SITE PLAN

PERRY TOWNSHIP, LAKE COUNTY, OHIO

for: PAT CRANE (CLIENT, OWNER)

30 (SUBLOT NO.) LARCHVIEW AVE. (STREET)

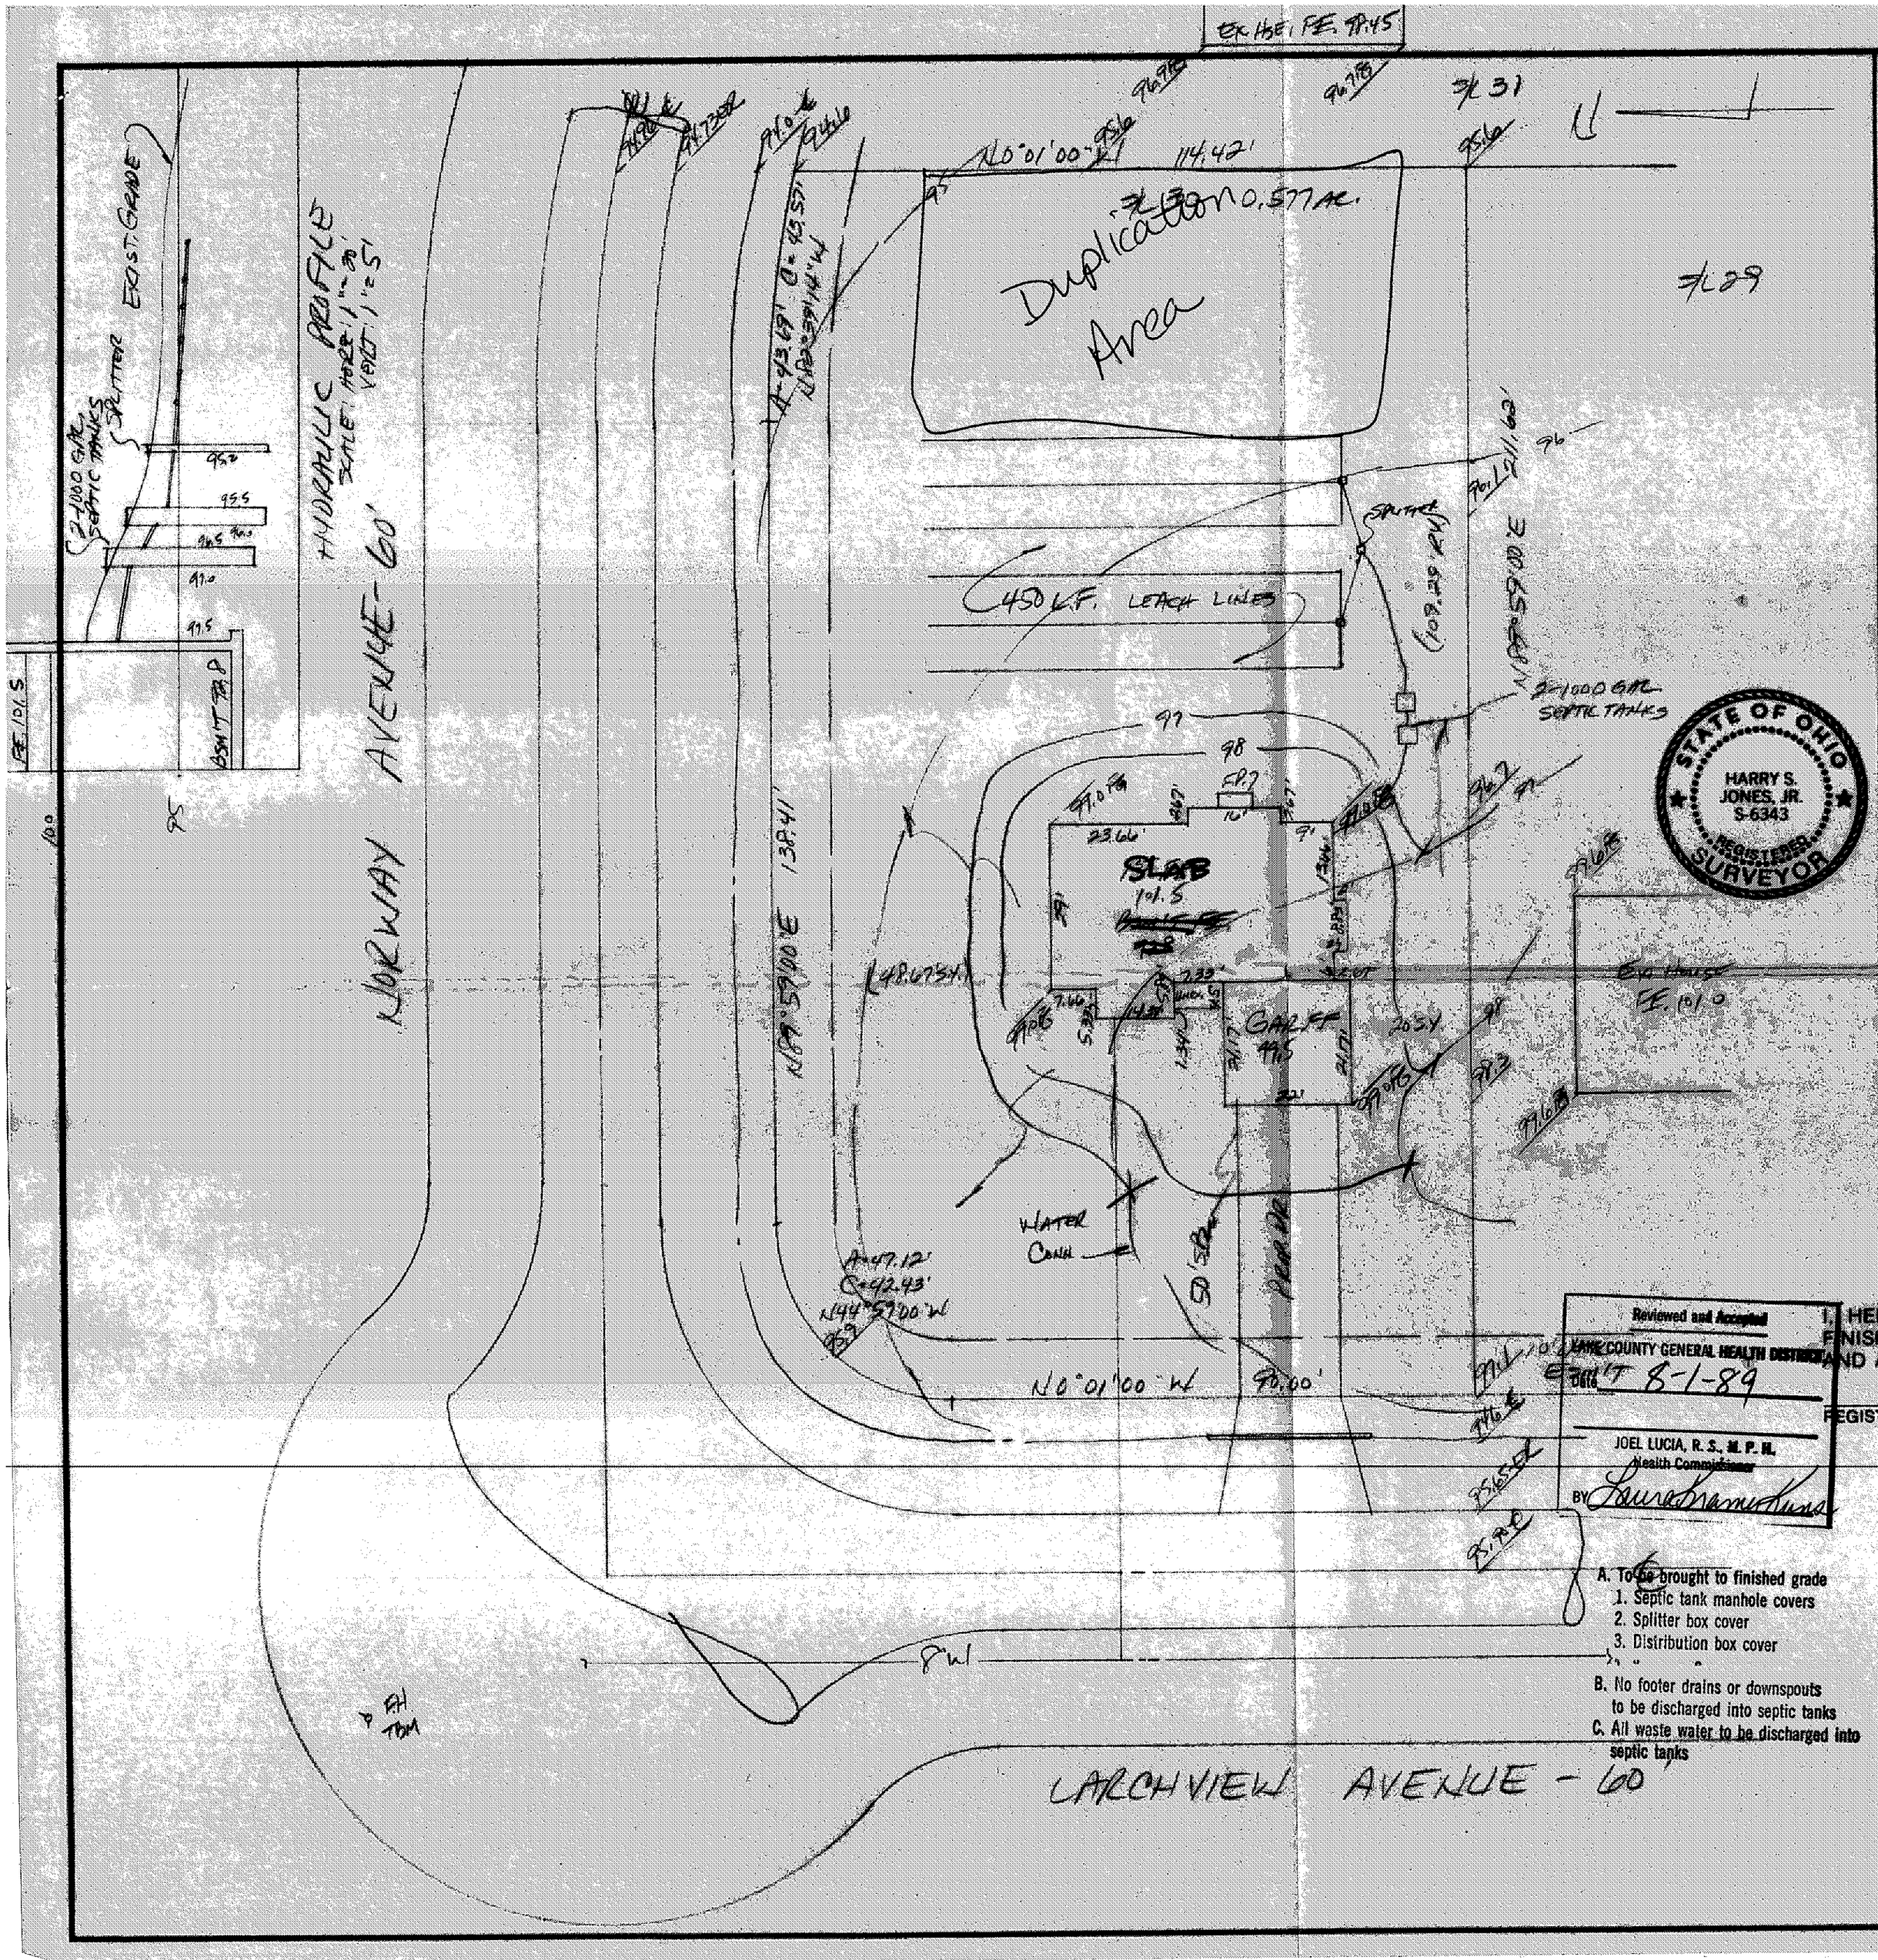
A. To be brought to finished grade
1. Septic tank manhole covers
2. Splitter box cover
3. Distribution box cover

B. No footer drains or downspouts to be discharged into septic tanks

C. All waste water to be discharged into septic tanks

1. CONTINGENT UPON ZONING PERMIT
2. 12" DRIVE CULVERT

LOW YIELD WATER FIXTURES REQUIRED ON ALL:
__ Shower Head
__ Toilet
